S100 18-Slot Backplane with Active Termination (REV 1.0)

Thankyou for your contribution to the 18-Slot S100 Backplane project! An initial run of 30 boards were produced and marked "REV 1.0" this can be found on the underside of the board. This document refers to REV 1.0 of the design, there is currently no further revisions of the board (as at 17th May 2014) however if you have a board that is of higher revision please refer to the documentation applicable for your board.

Figure 1

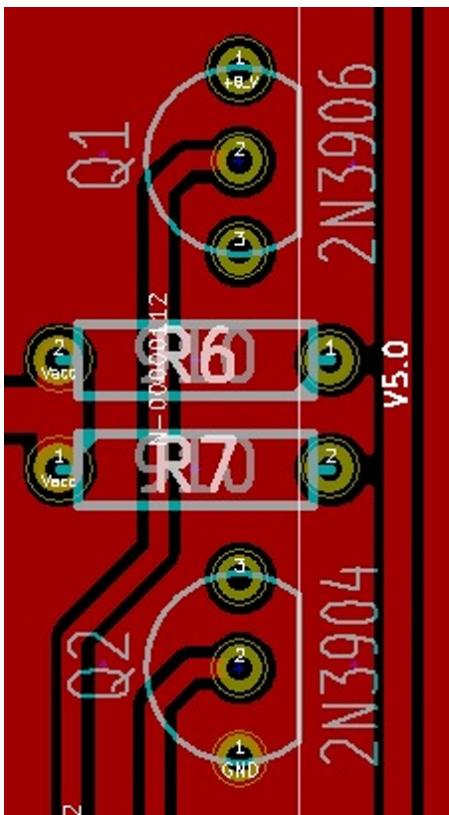
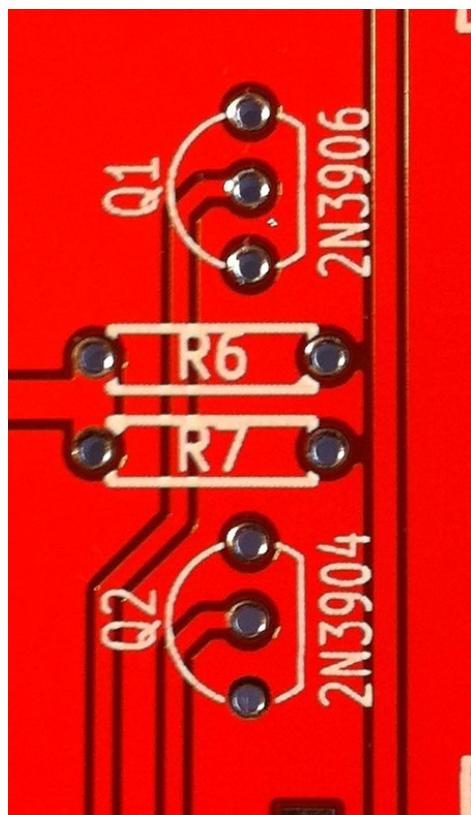
There is a fix required on REV 1.0 of the board. This involves a 180° rotation of Q1 (2N3006). This was a result of an incorrect footprint in the design software, as one will notice by figure 1, pins 1,2,3 of Q1 are in the opposite orientation to Q2. These items both have the same package and should both use the same footprint (Q2 is the correct footprint). Q2's silkscreen is correct and should be installed as per the silkscreen on the board. Q1's silkscreen is incorrect and should be rotated 180° (installed backwards). Please refer to Figure 3 and 4 for correct installation orientation.

Figure 1 (below) shows the incorrect pin numbering of Q1 with reference to Q2 being correct for the TO-92 package in the design software. Figure 2 shows the actual board silkscreen (Q1 footprint incorrect)

Figure 3 (above)

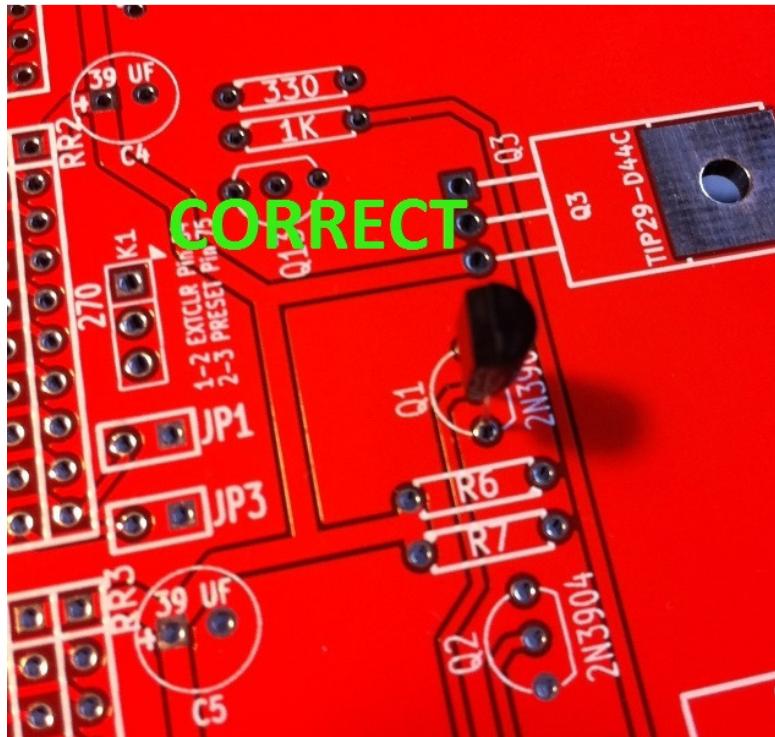
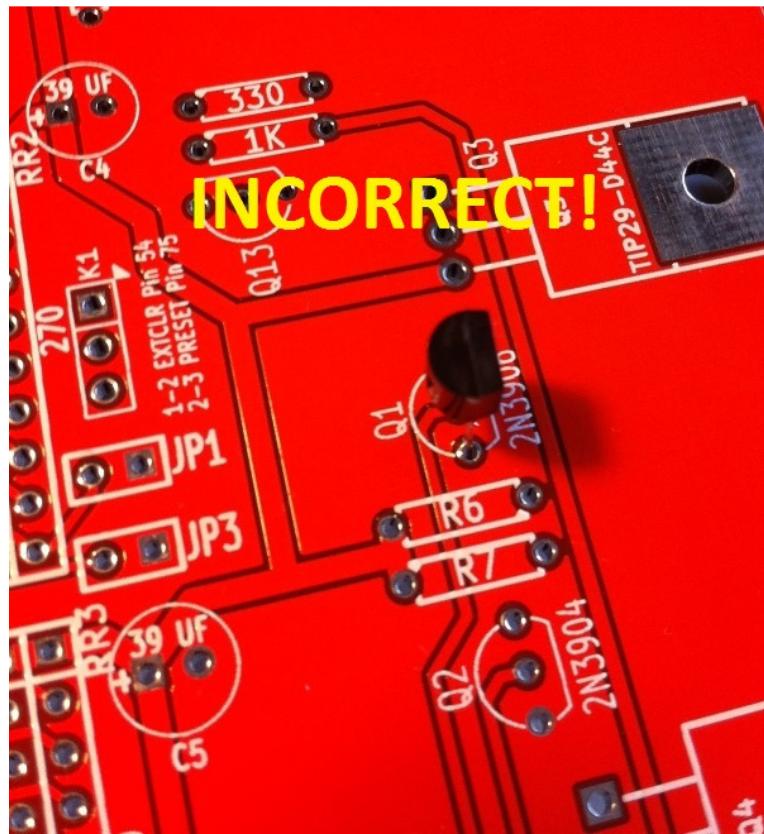
Figure 3 below shows the Correct installation of Q1. Figure 4 shows the incorrect installation of Q1.

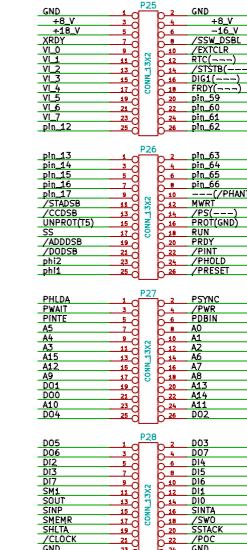
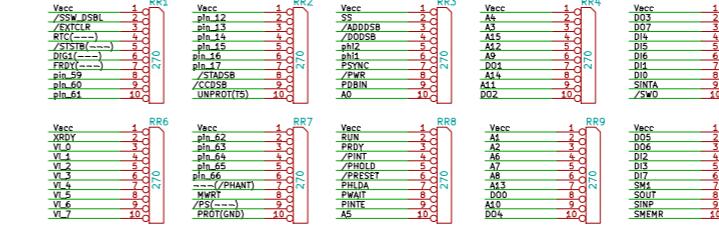
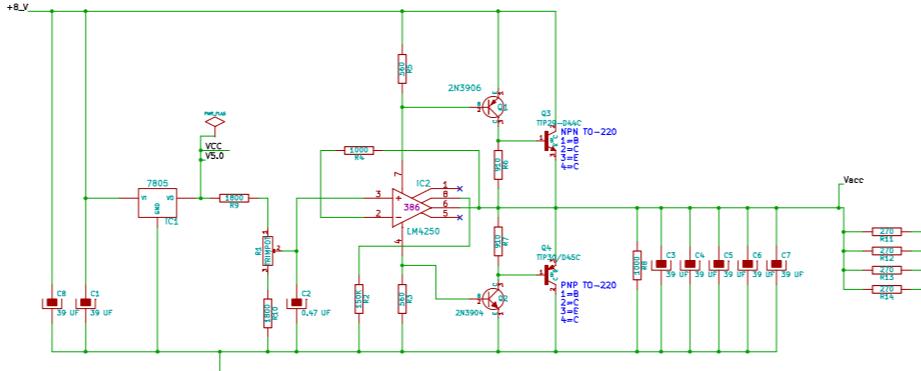
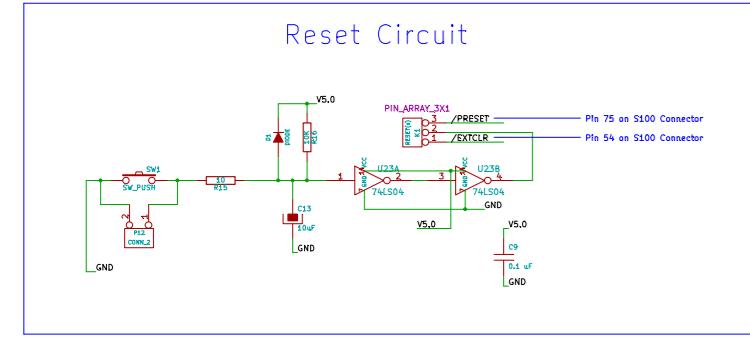
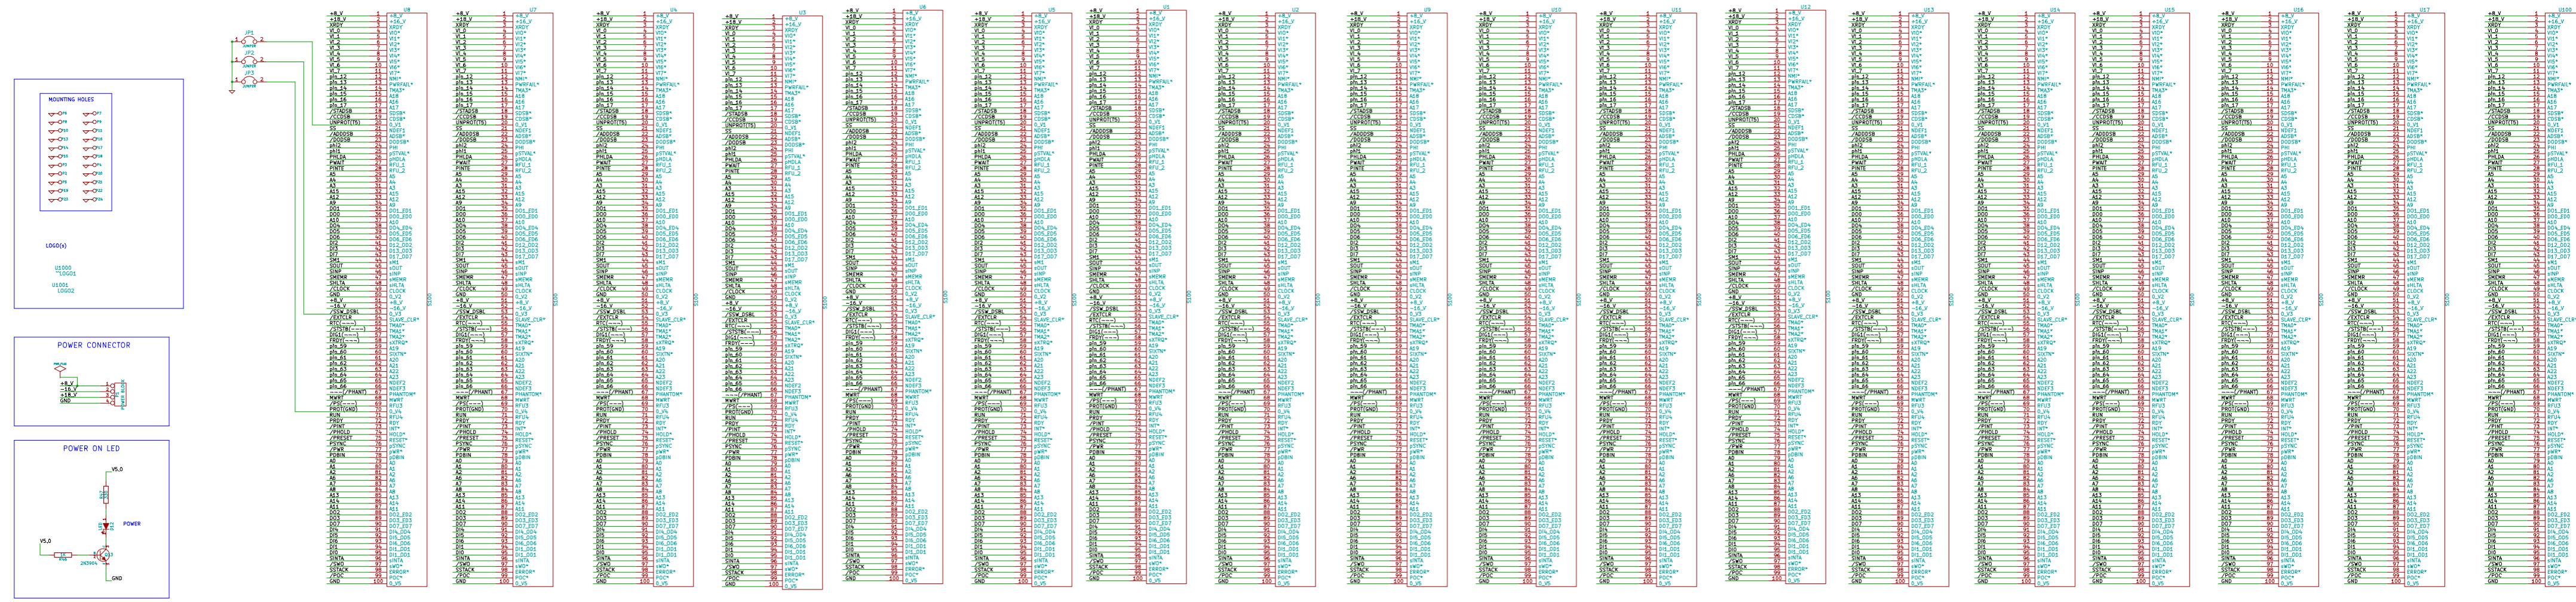
Some initial testing of the system reset function revealed that K1 should be the only device pulling high or low Pin 54 or Pin 75 on the S-100 bus. If there is any other board present in the system that contributes to this the line, the line should be disabled on that board. Or K1 should be left "open" and no jumper installed. There is still some testing to be done on this circuit. A possible solution could be modify the signal coming from U23 pin 4. K1 pin 2 to be pulled high by a 10K ohm resistor and going to an open-collector input of a suitable transistor being driven by U23 pin 4
